This 1:200 scale adjacency plan (based on SoA v8.0), which identifies the extent and departmental relationships and reflects the operational requirements of the departments within the 3Ts Project, is confirmed as agreed by the Trust, subject to the following caveats:

PROJECT TITLE
Brighton 3Ts

DRAWING TITLE
Room Relationships - Security Kiosk - Level B1 Stage 1

DRAWING TITLE
Room Relationship: Main Entrance and Switchboard: Level 01 Stage 1

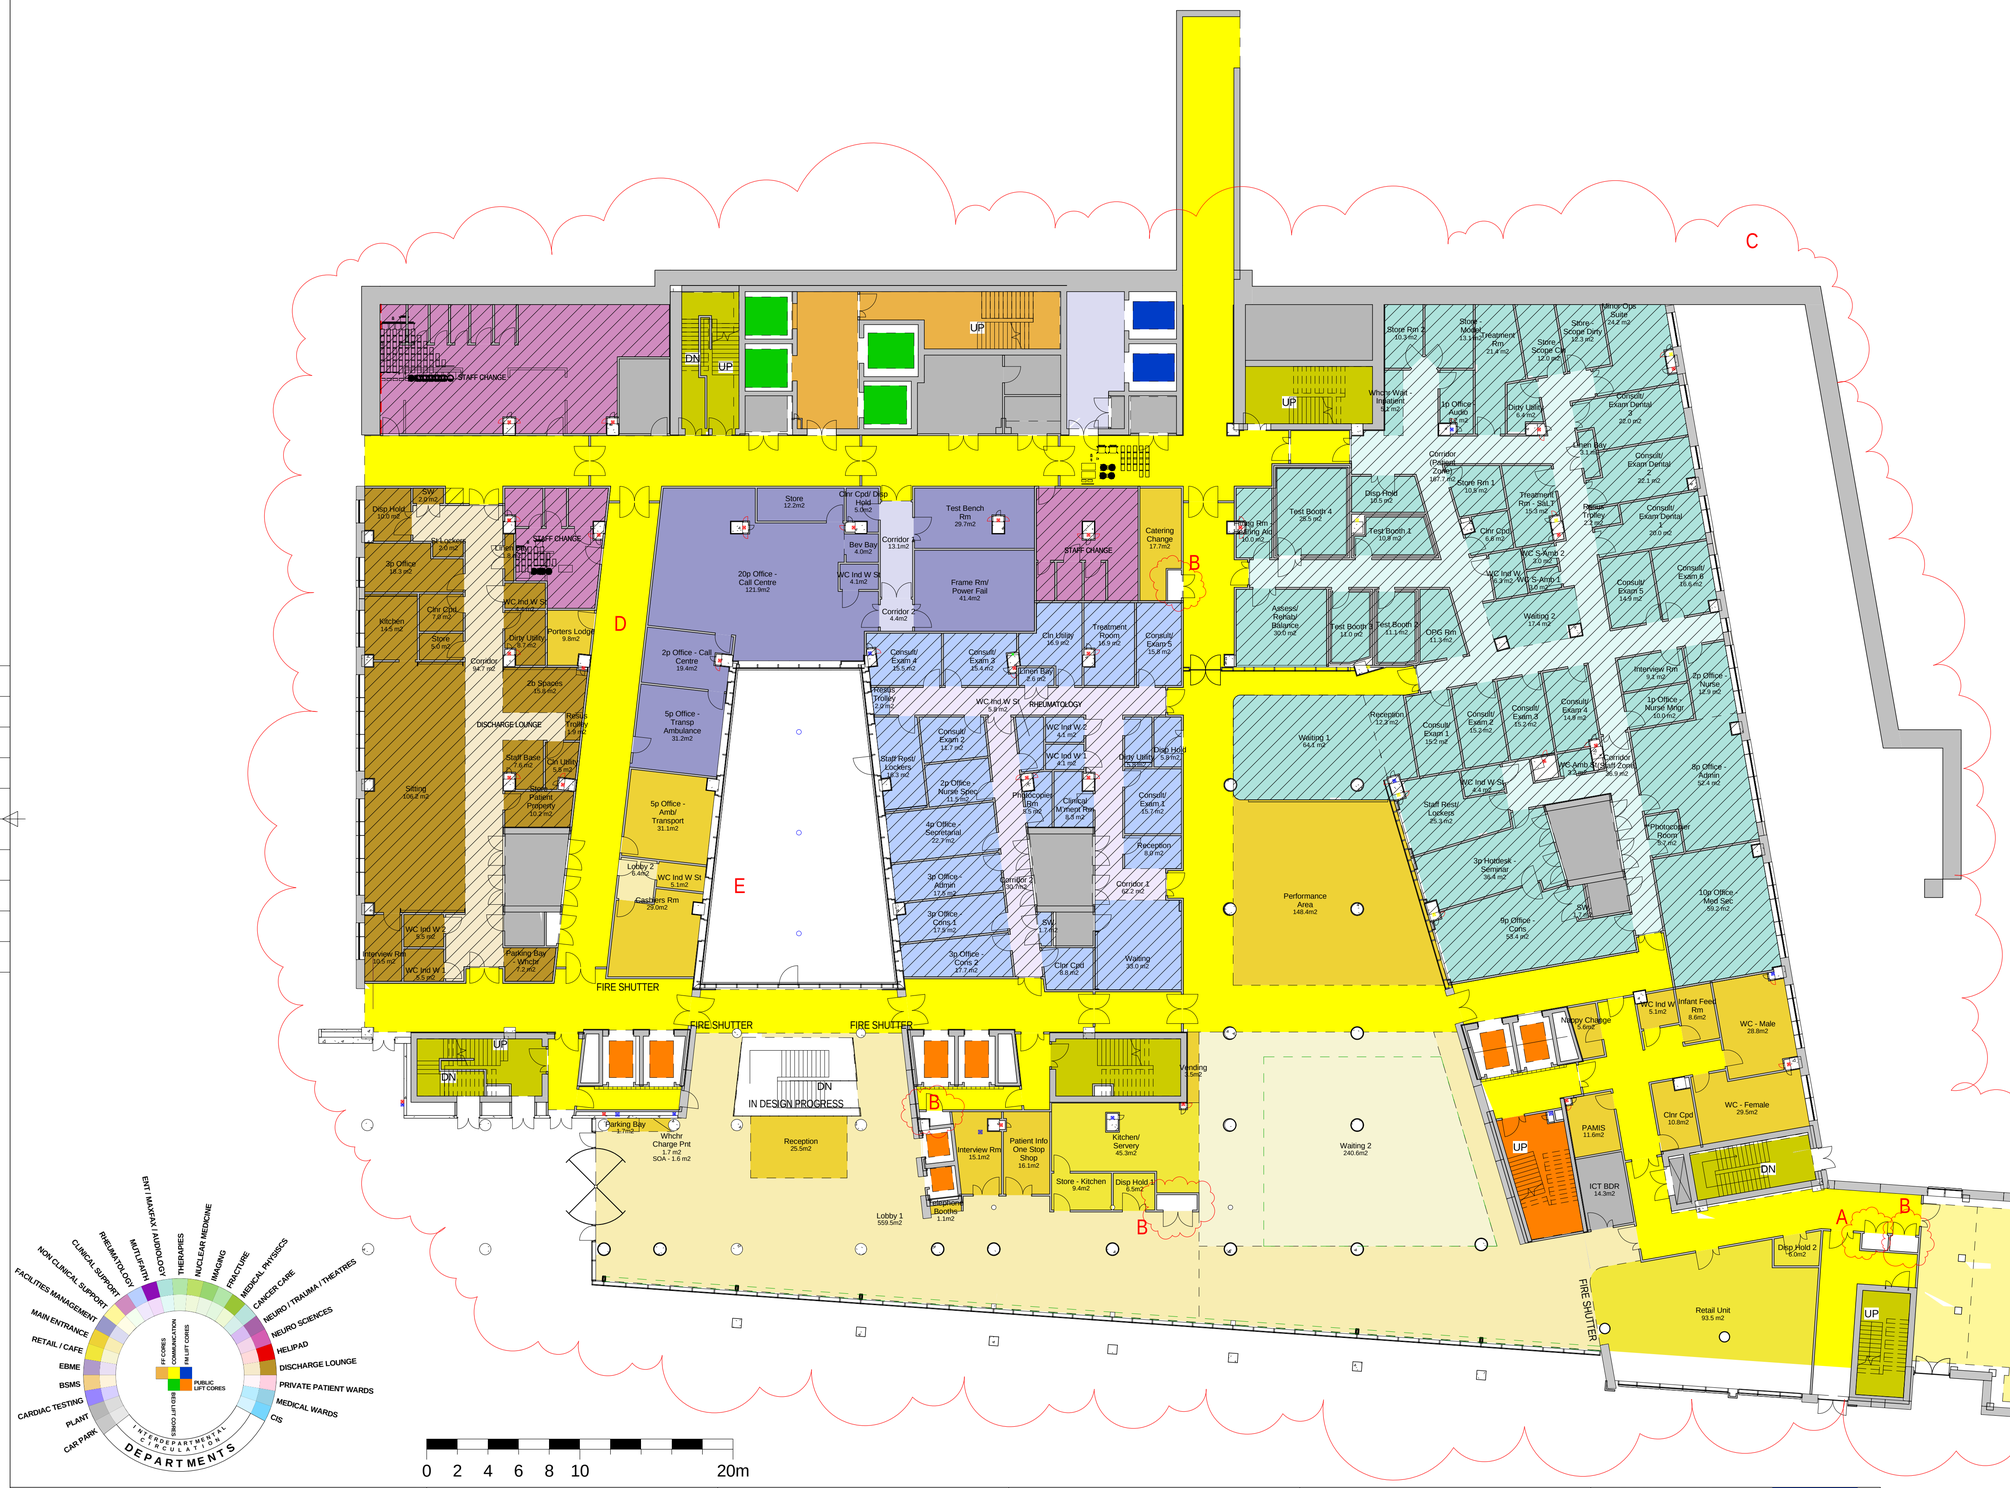
A	M & E Switch room added
B	M & E Manifold Rooms added
C	Elevation / Window co-ordination updated
D	ID Room moved to L02, replaced with relocated porters lodge. Trust request 19/07/11
E	Lobby and DWC relocated Trust request 19/07/11

DRAWING TITLE
Room Relationship: Nuclear Medicine: Level 02 Stage 01

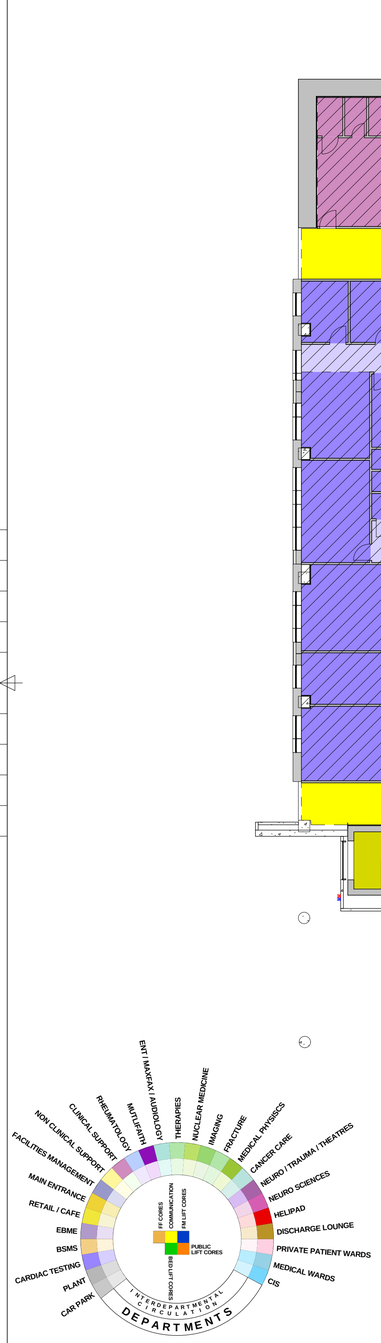
A Decontamination Point omitted

B Decontamination Point omitted

C Potential location for particle pump indicated

D WC Ind W realigned, Cleaner's Cupboard increased to 7.3m²

DRAWING TITLE
Room Relationship - Non-Invasive Cardiology, Therapies
Level 02 Stage 1

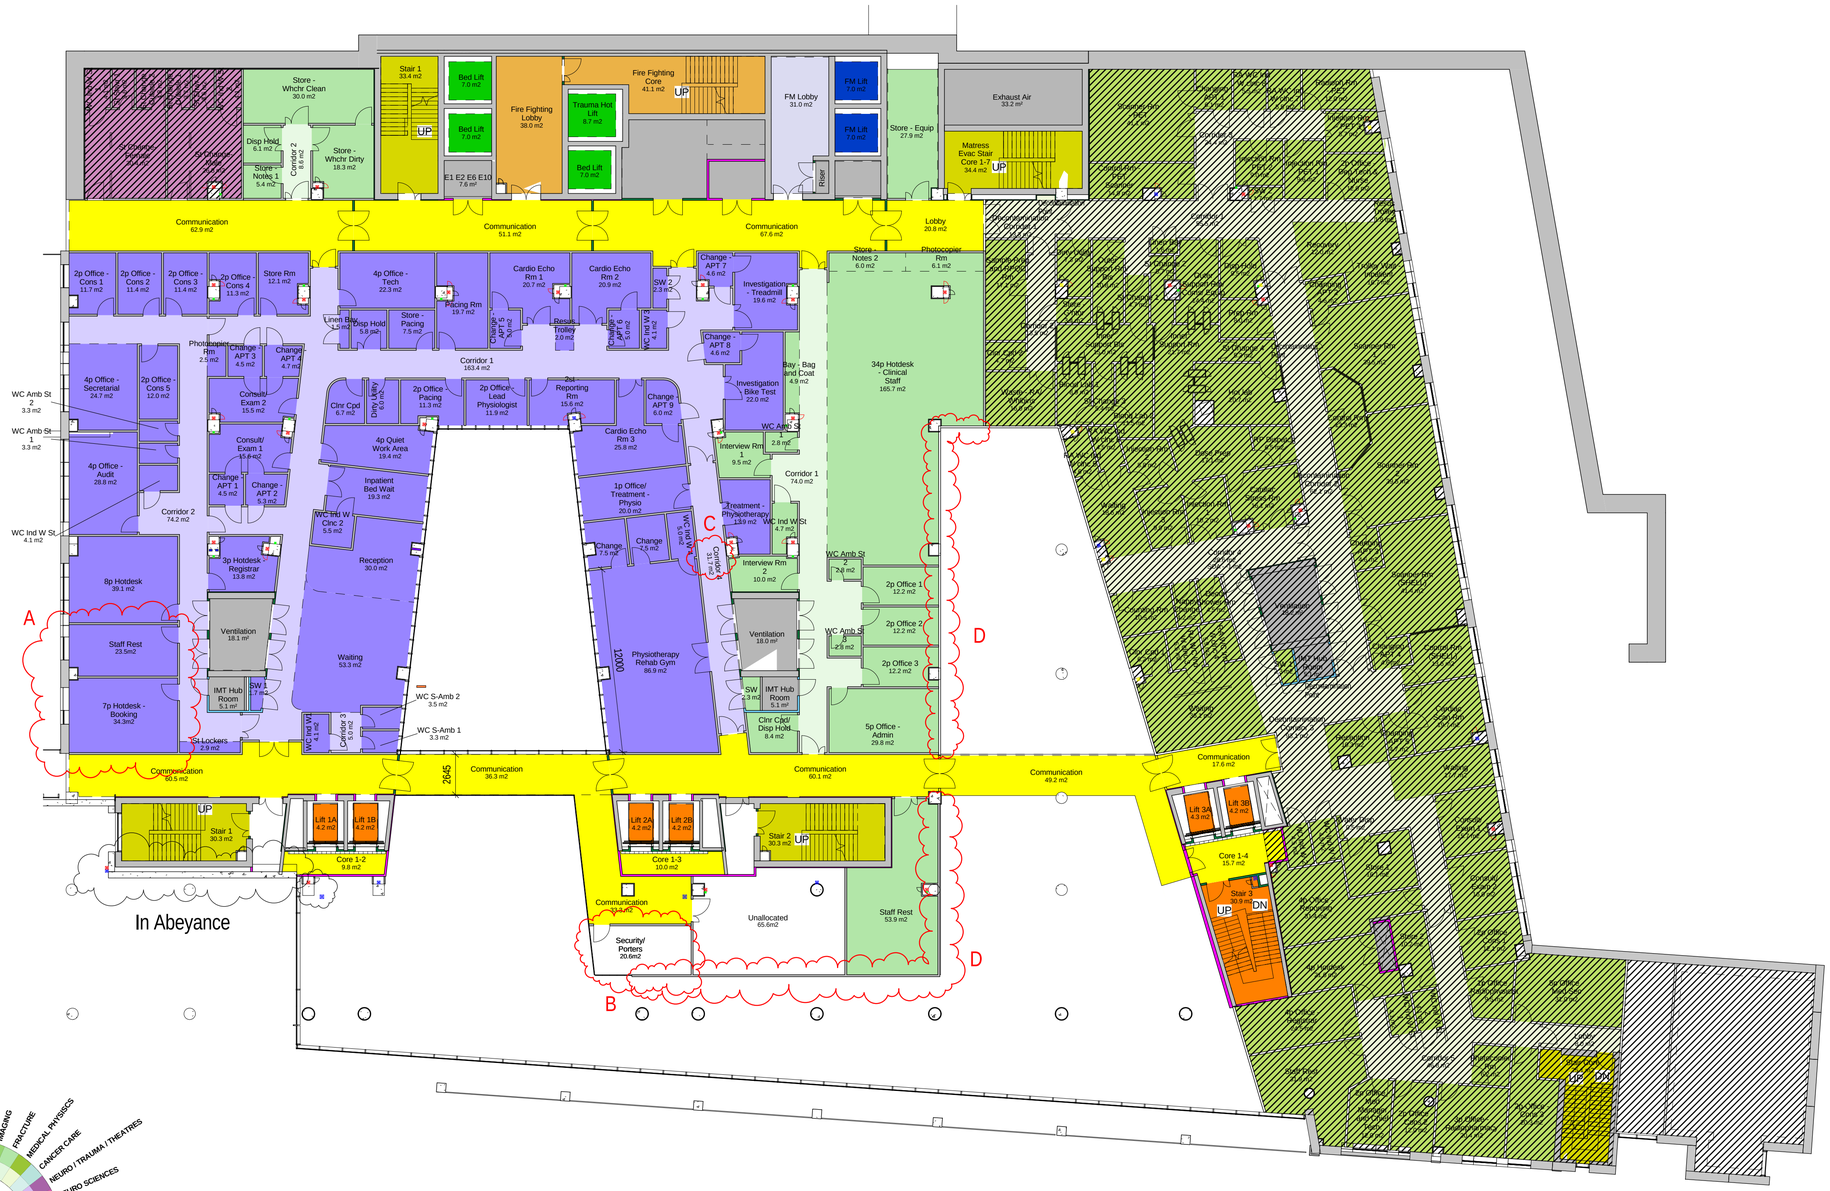
A 7 Person Hot Desk Booking and Staff Rest swapped to improve window coordination

B 3p Security - Porters, size increase from 15m2 to 20m2

C Superfluous corridor door removed

D Window co-ordination ongoing

DRAWING TITLE: Room Relationship: Facilities Management: Level 03 Stage 1

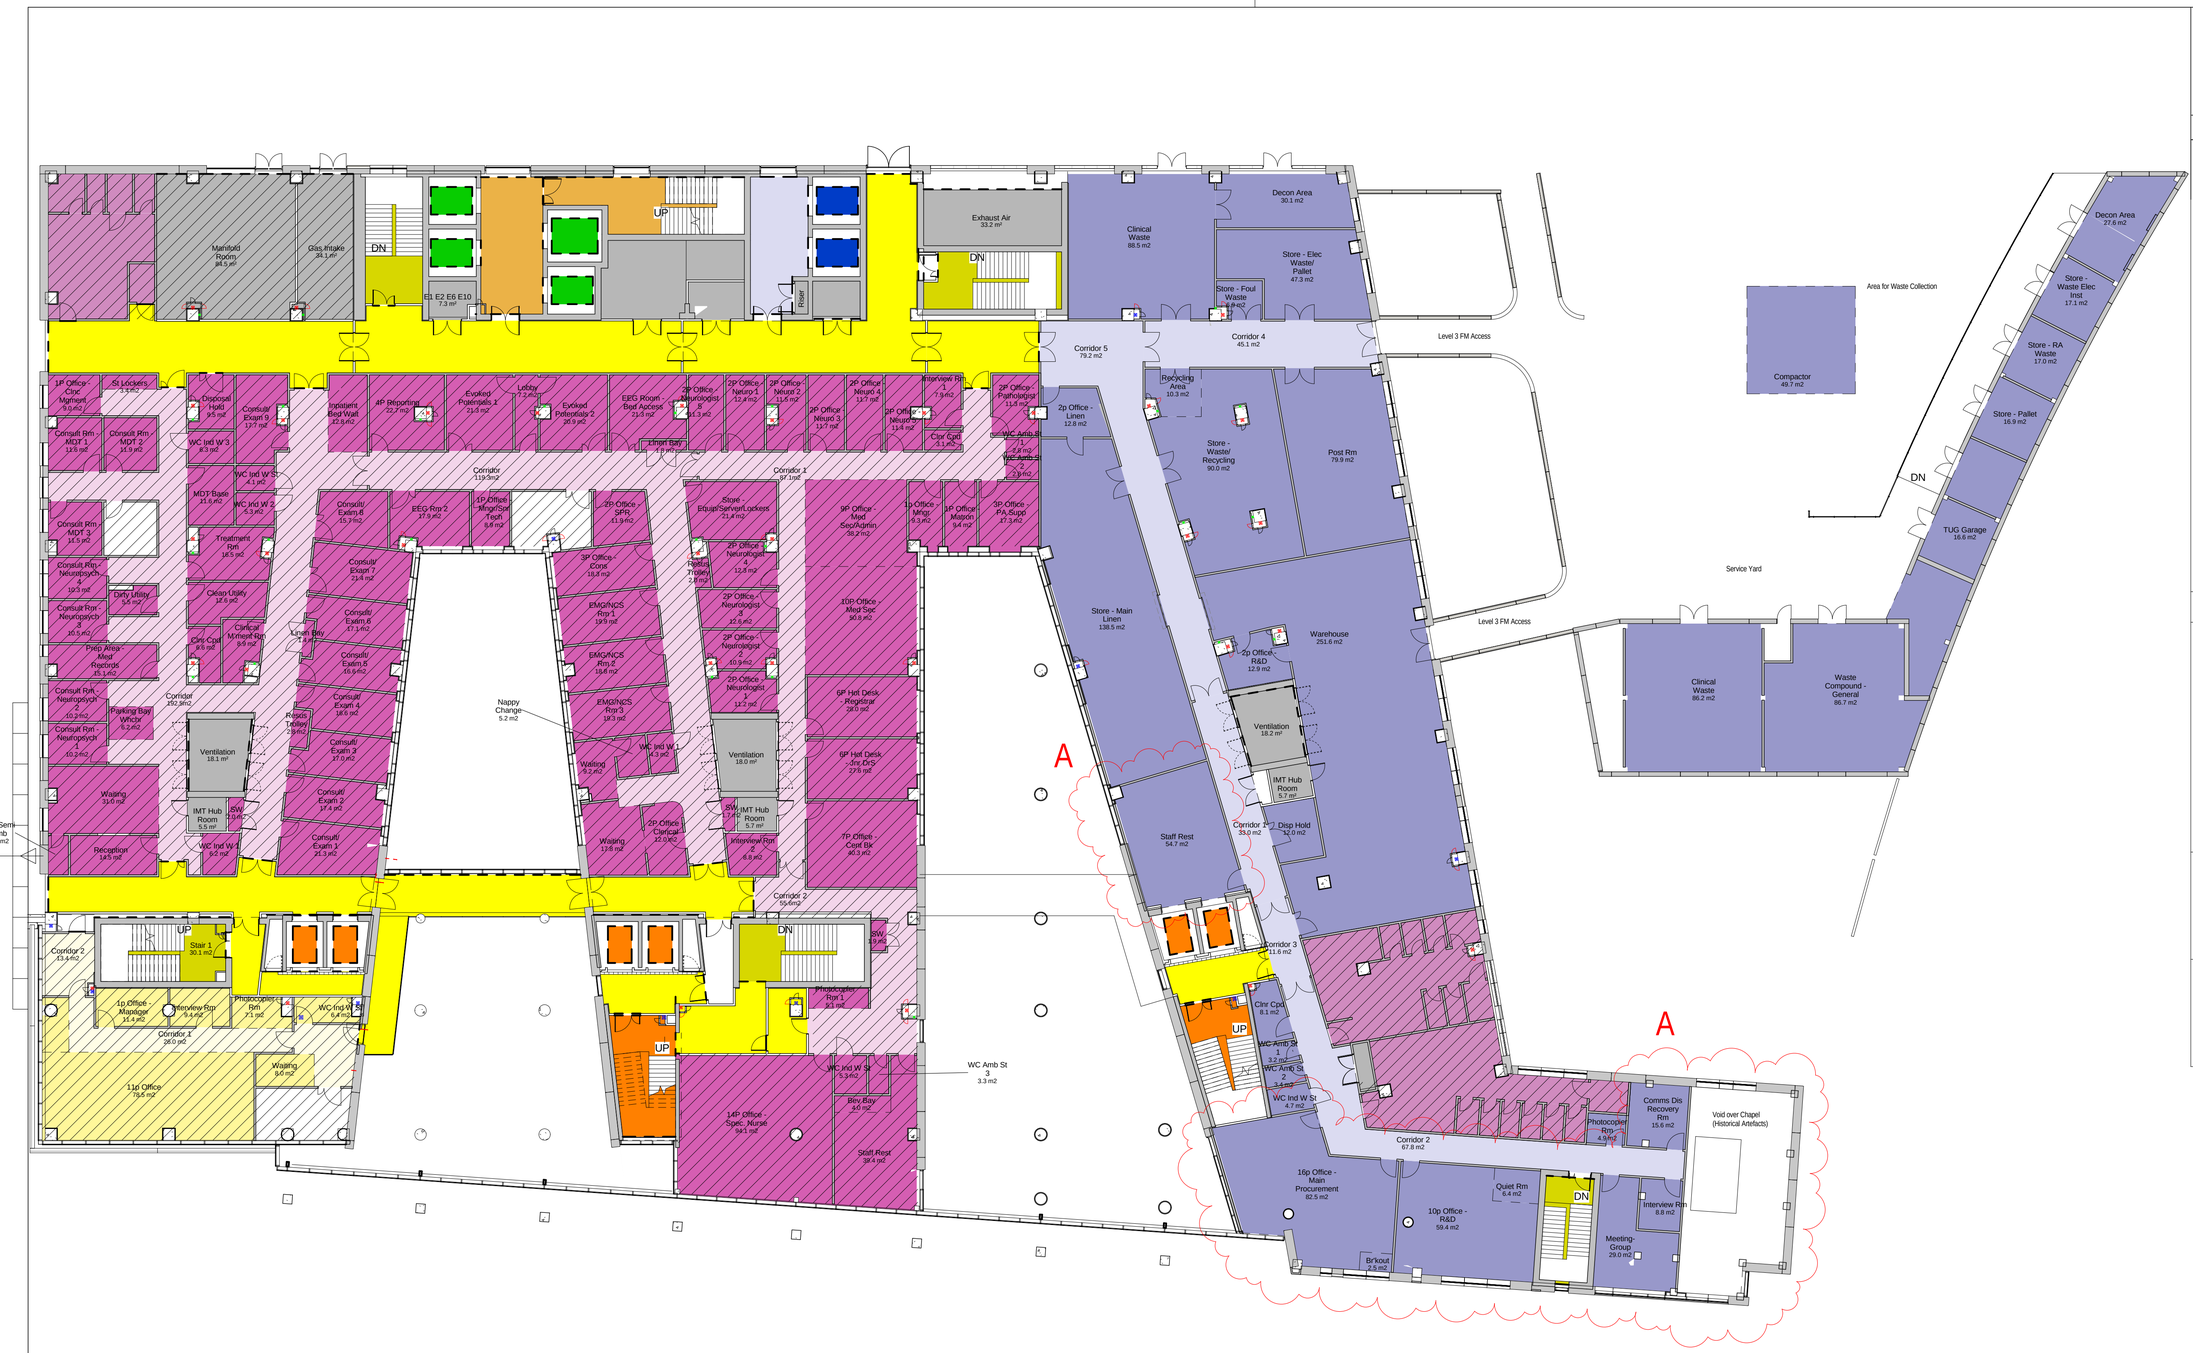
A Void above chapel indicated on Level 3, 16 Person Main Procurement Office relocated, adjacent office accommodated reconfigured to suit. Staff Rest moved to previously unallocated space
